CHANGE ORDER NO. 11

PROJECT: West Sewage Treatment Plant (STP) Improvements  
 OWNER: City of Crest Hill, Illinois  
 CONTRACT: 1-2022  
 CONTRACTOR: Vissering Construction Company

Cost Proposal Request  
West Sewage Treatment Plant Improvements  
City of Crest Hill  
Contract 1-2022  
August 26, 2025

**Drawing 99-E6.03 - Electrical SCADA Riser Diagram**

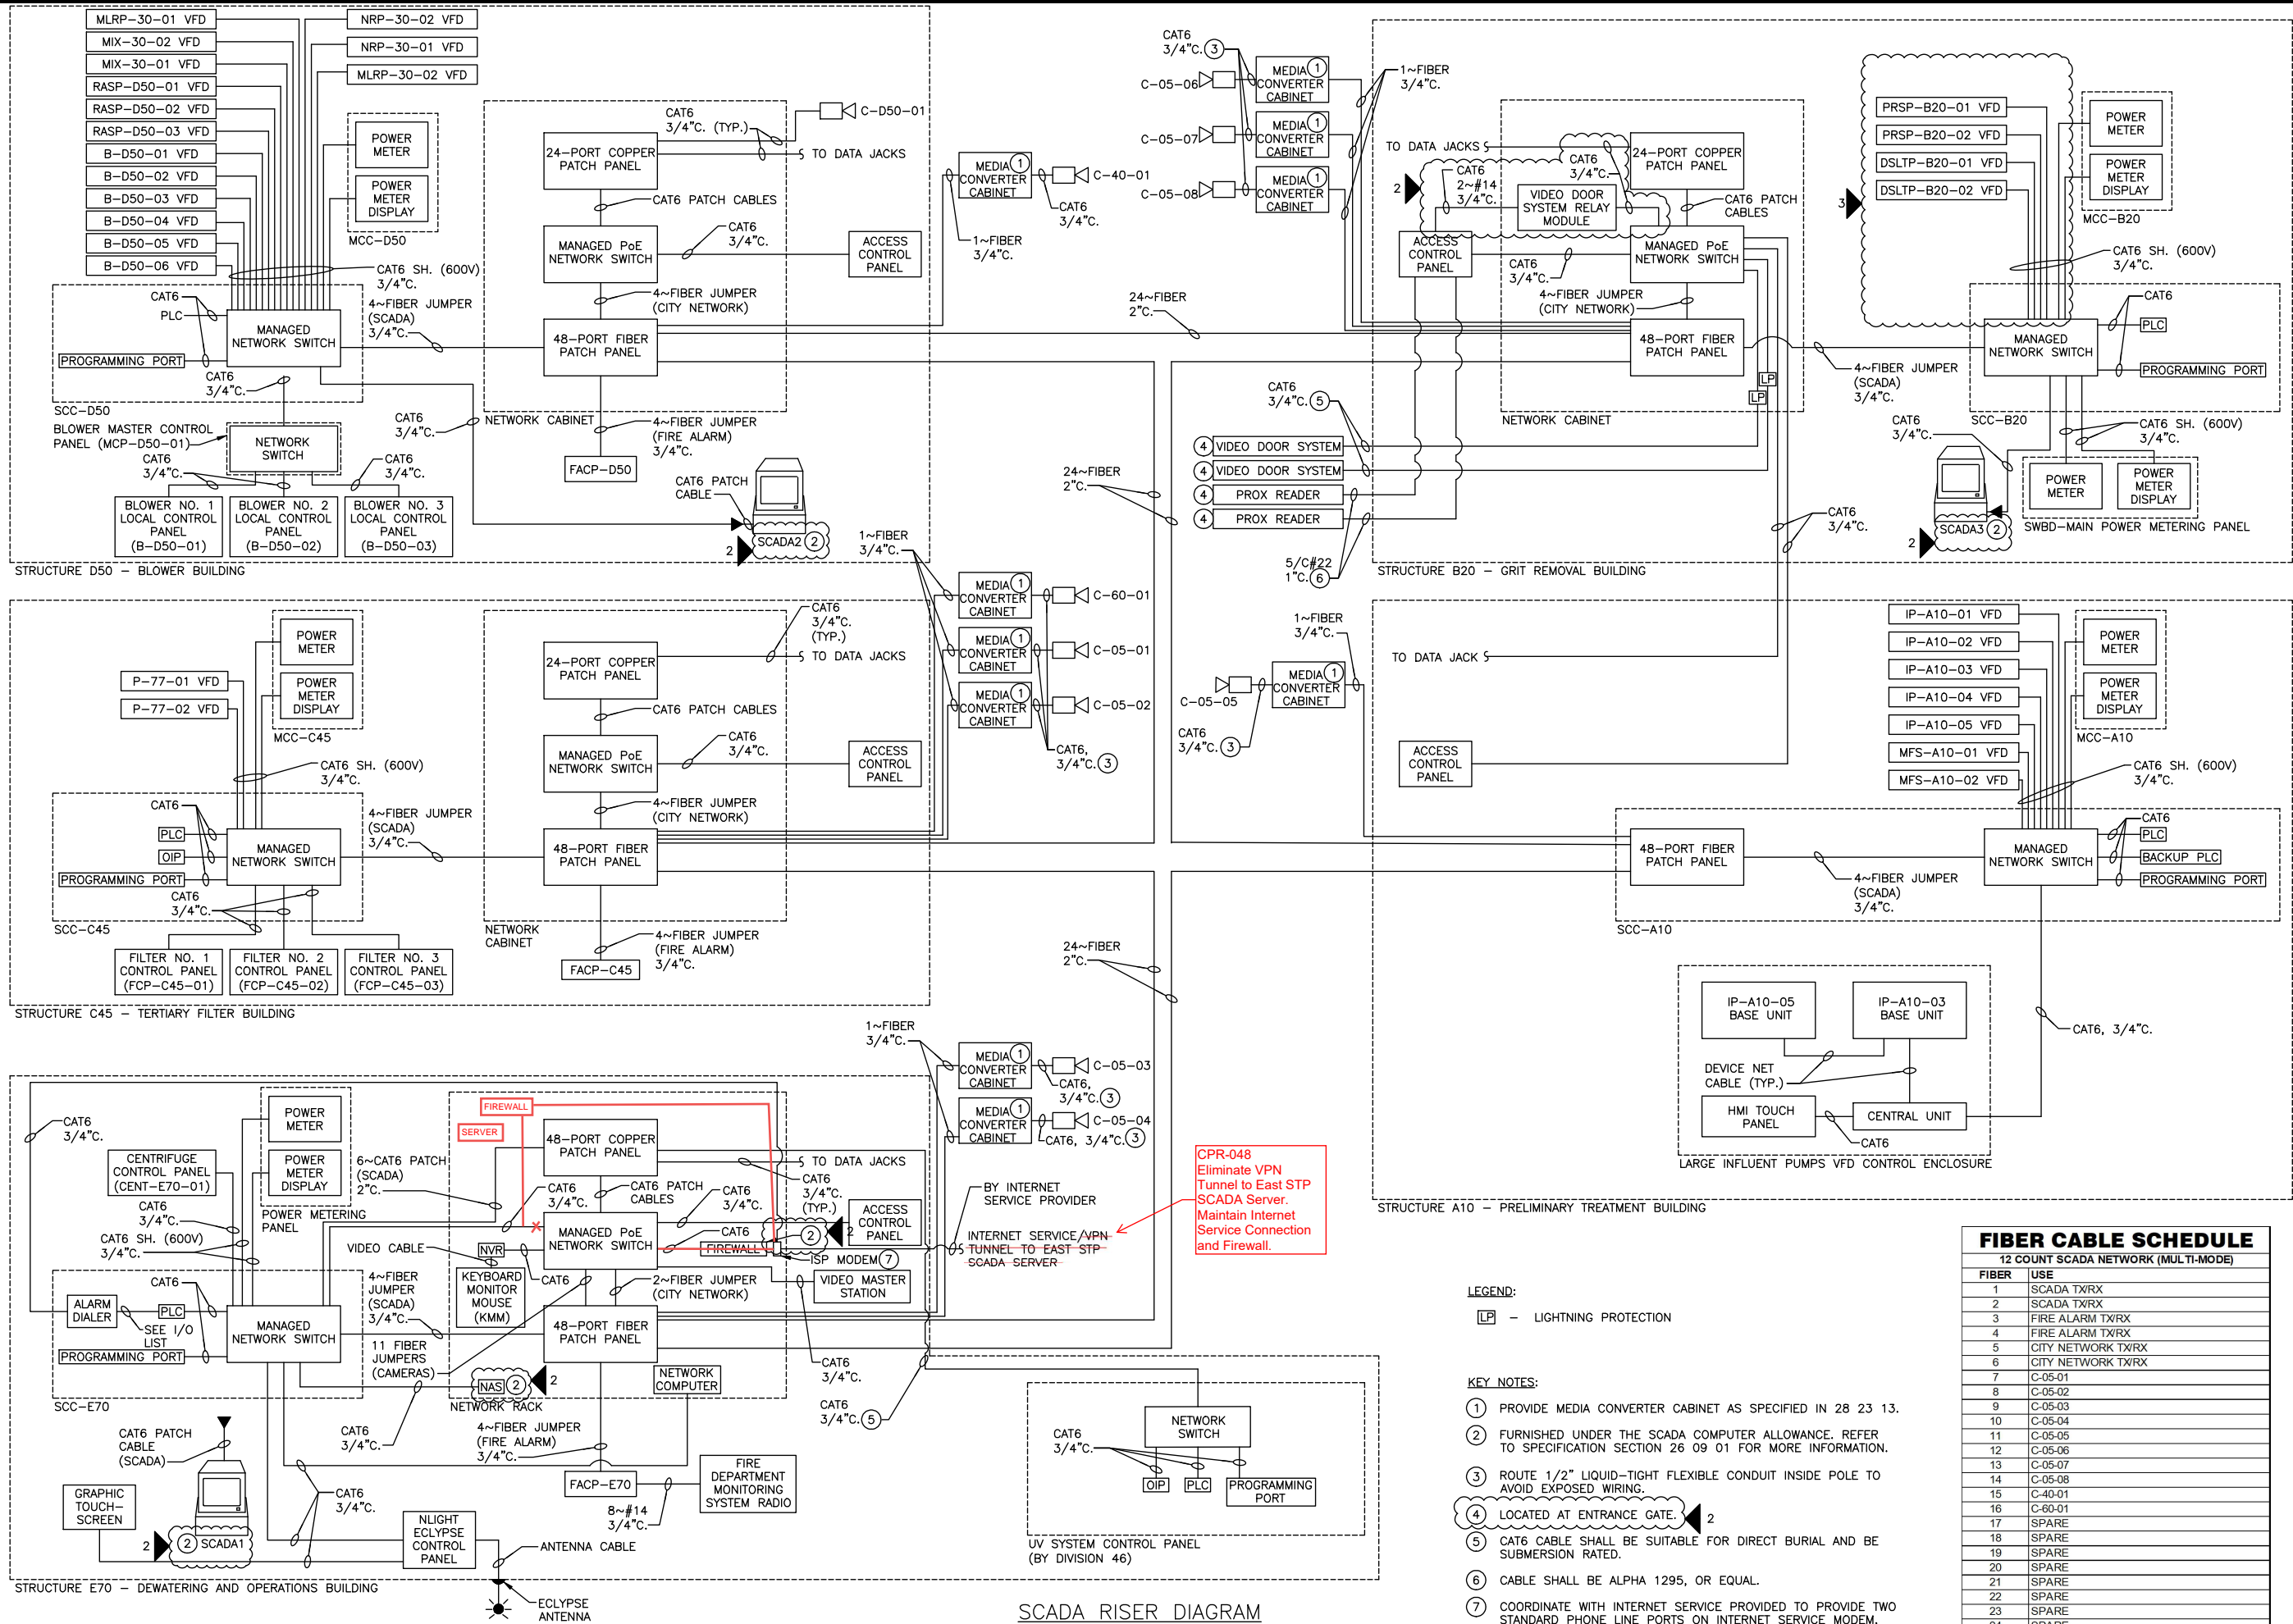
048-05 See attached mark-up.

**Drawing 99-E6.03 - Electrical SCADA Riser Diagram**

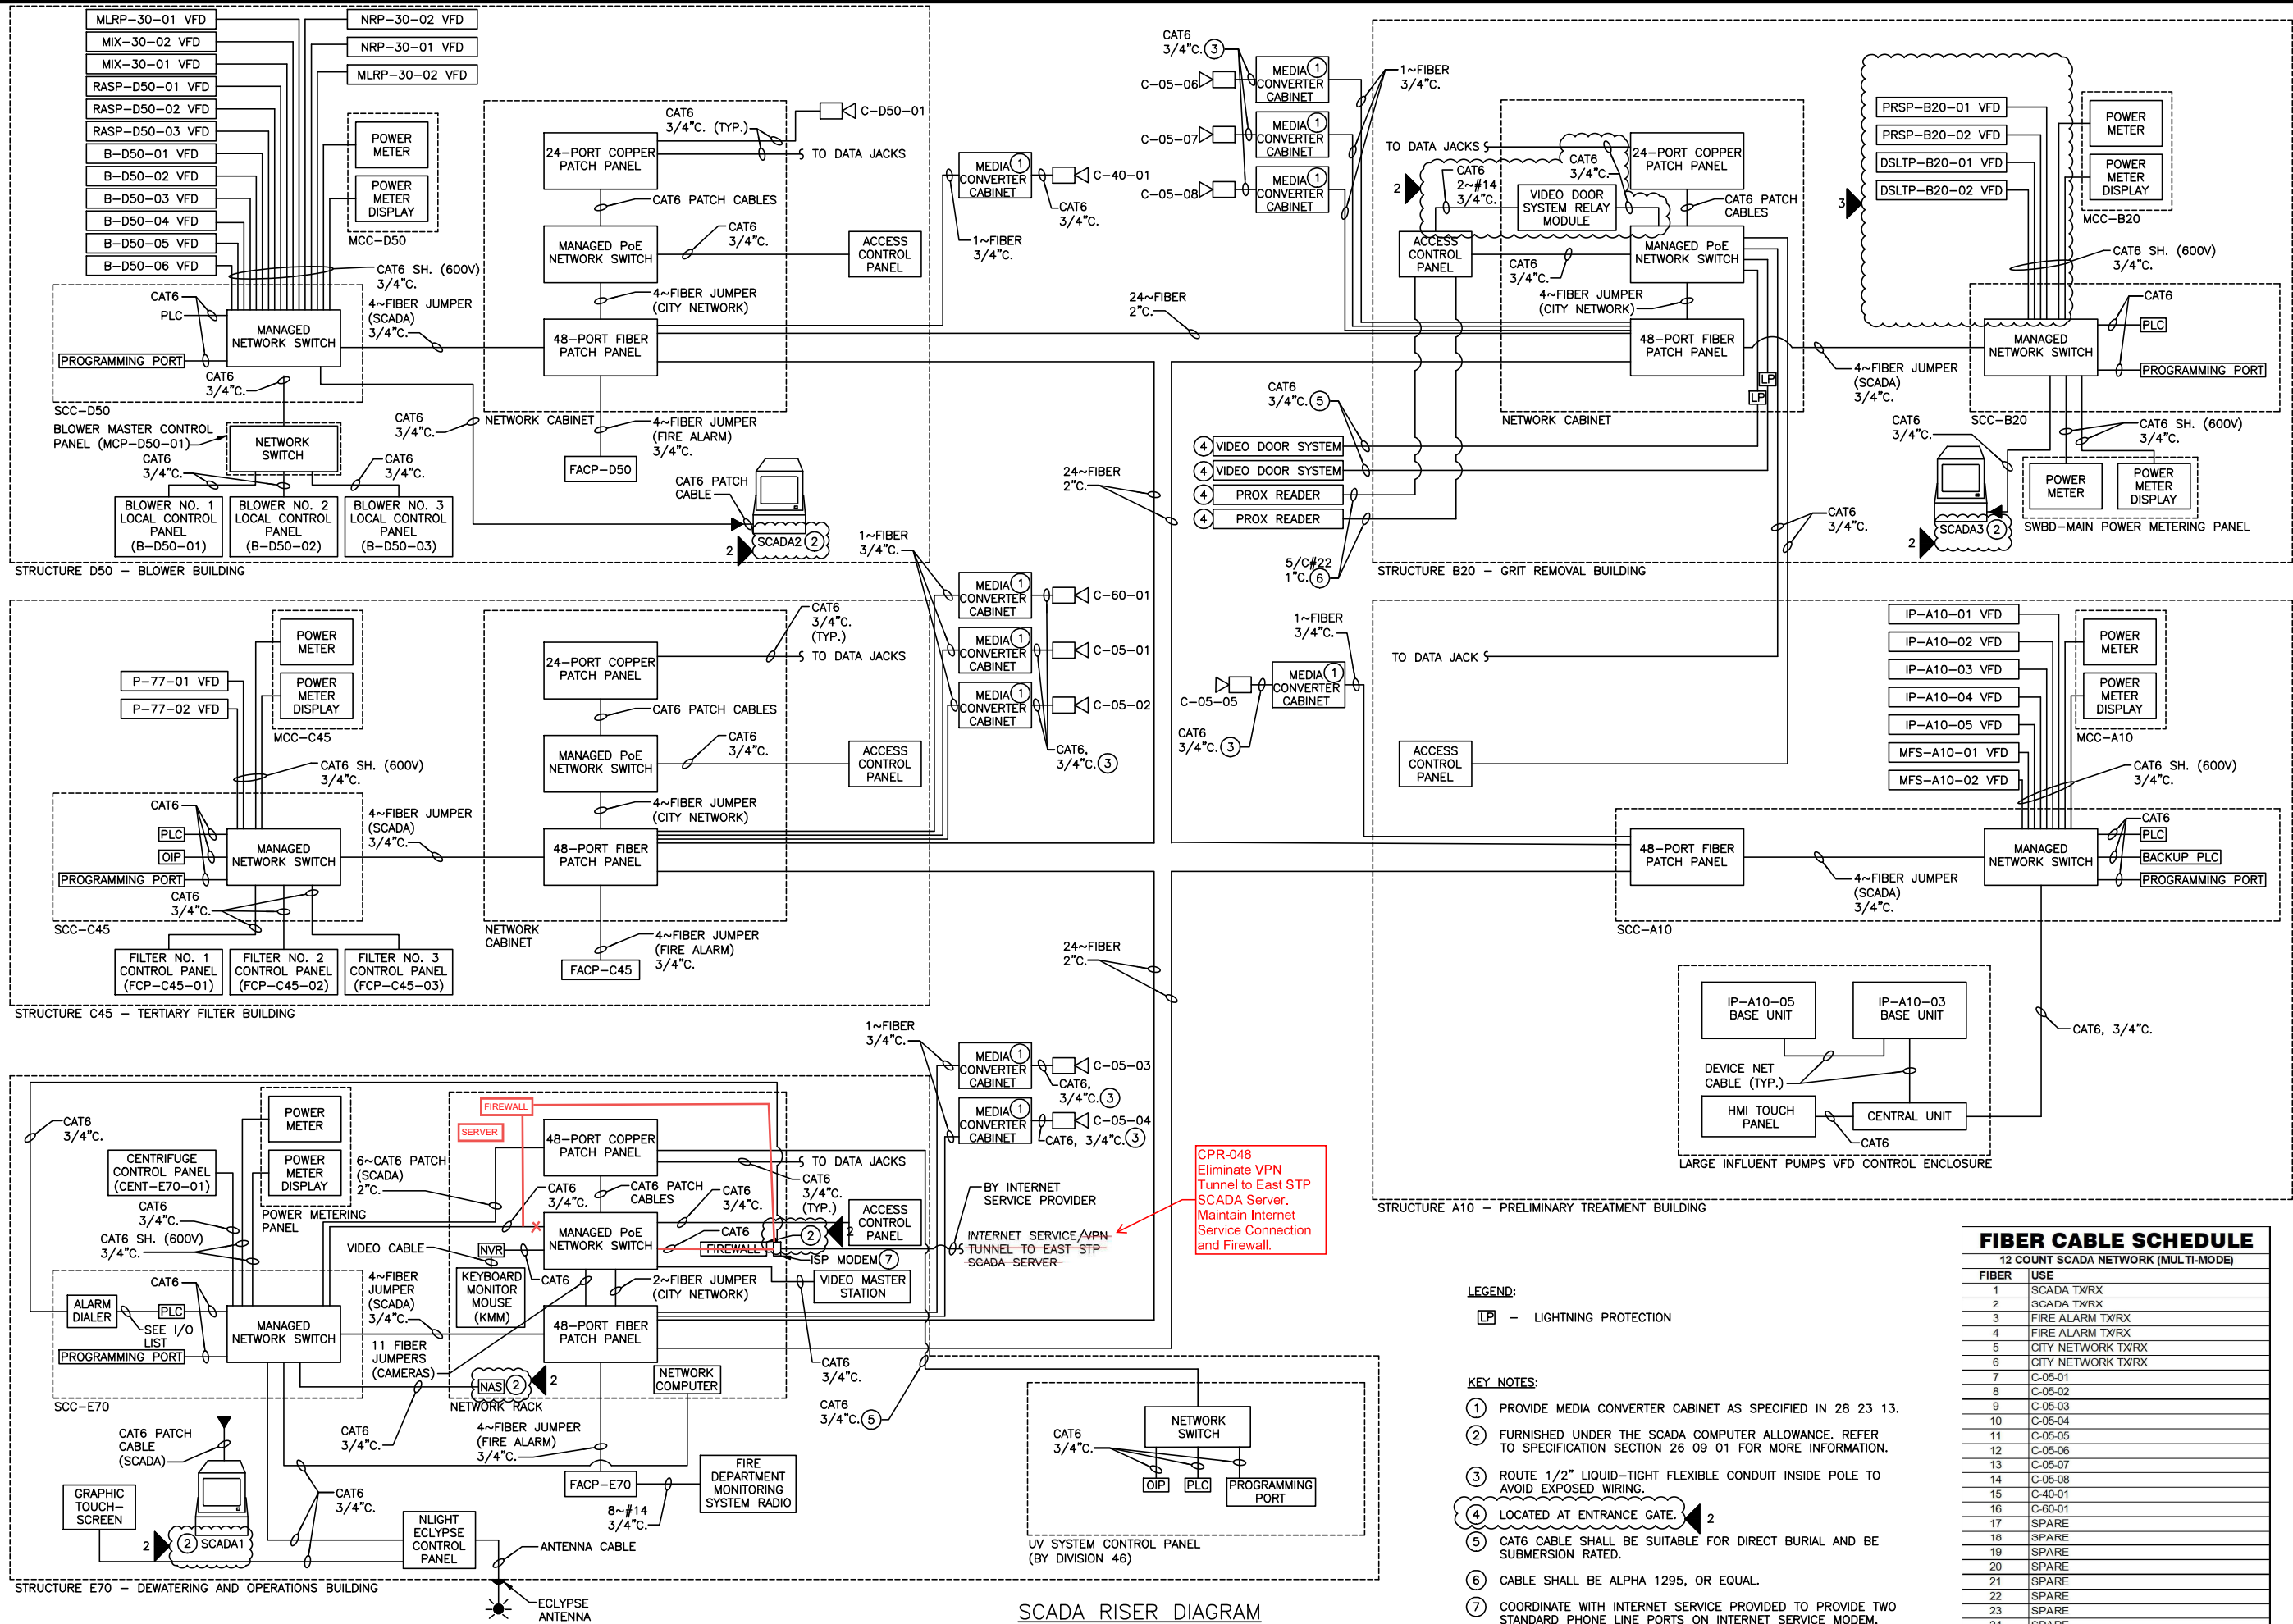
048-05 See attached mark-up.

**Drawing C45-E1.01 - Tertiary Filter Building - Electrical Plan**

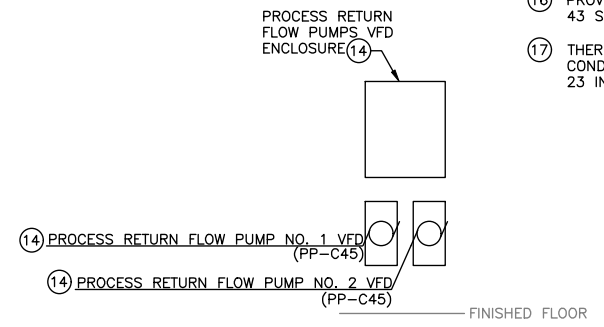
Please submit an itemized quotation for changes in the Contract Price and Time incidental to proposed modifications to the Contract Documents described herein. The purpose of this request is to add additional emergency stop push buttons nearer the tertiary filter equipment.

**Drawing C45-E1.01 - Tertiary Filter Building - Electrical Plan**

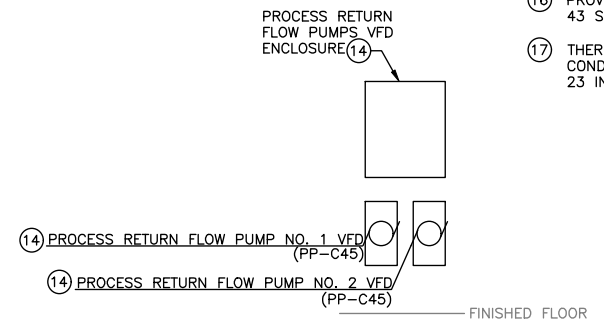
Please submit an itemized quotation for changes in the Contract Price and Time incidental to proposed modifications to the Contract Documents described herein. The purpose of this request is to add additional emergency stop push buttons nearer the tertiary filter equipment.
